Sept. 19, 2017

Re: **Kejimikujik National Park Administration Building Roof Anchorage**

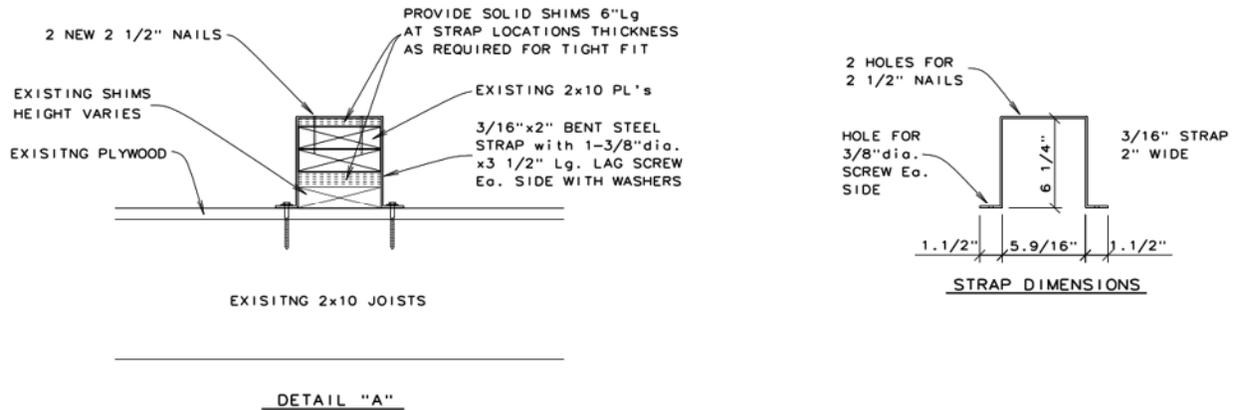
Each piggyback truss should have a new Simpson H2A anchor installed to connect the piggyback truss to the lower main truss across the 1x4 or 2x4 plate that separates them. That should be done at each end of the piggyback truss.

Each main truss should be connected to the double plates at each end of the trusses with a Simpson H2.5 anchor.

The double plates need to be connected to the 2x10 joists below the sheathing. Due to the fact that the distance from the top of the double plates to the existing joists below the sheathing varies due to the slopes for drains, two systems are required. Where double plates and shims do not exceed 3 1/2" in height, one 5" long Simpson Strong-Drive SDW EWP-PLY screws should be screwed through the plates and existing plywood deck, into every joist where existing joist spacing is 16". Where existing joist spacing is 12", use one Simpson Strong-Drive SDW EWP-PLY screw every second joist. Where the double plates and shims are in excess of 3 1/2" high and up to 4 1/2" high, use 6" Simpson Strong-Drive SDW EWP-PLY screws. At locations where double plates and shims exceed 4 1/2" in height use steel strap and screws as shown on detail A.
